AMENDMENTS TO THE DRAWINGS

Please substitute the enclosed sheets 2/7 and 6/7, labeled “Replacement Sheets,” for the corresponding sheets presently in the case. Also enclosed, labeled Annotated Marked-up Drawings, are marked-up copies of each Replacement Sheet indicating the changes.

FIG. 8

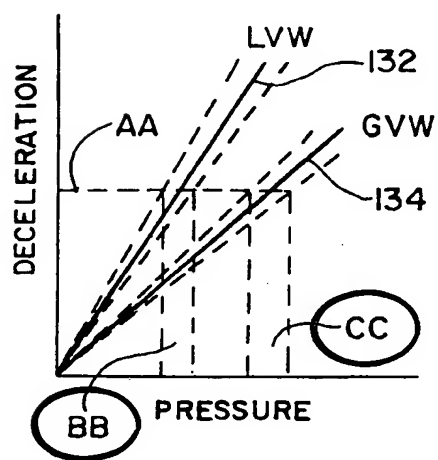
An objection was made to the use of reference letters “B” and “C”. Fig. 8 is amended to designate regions BB and CC, it being noted AA was changed by previous amendment.

The specification is amended at page 15 to clarify that the RPC controller is ECU 70 in the described embodiment, and at page 19 to refer to AA, BB and CC in Fig. 8, consistent with the amendments to the figure.
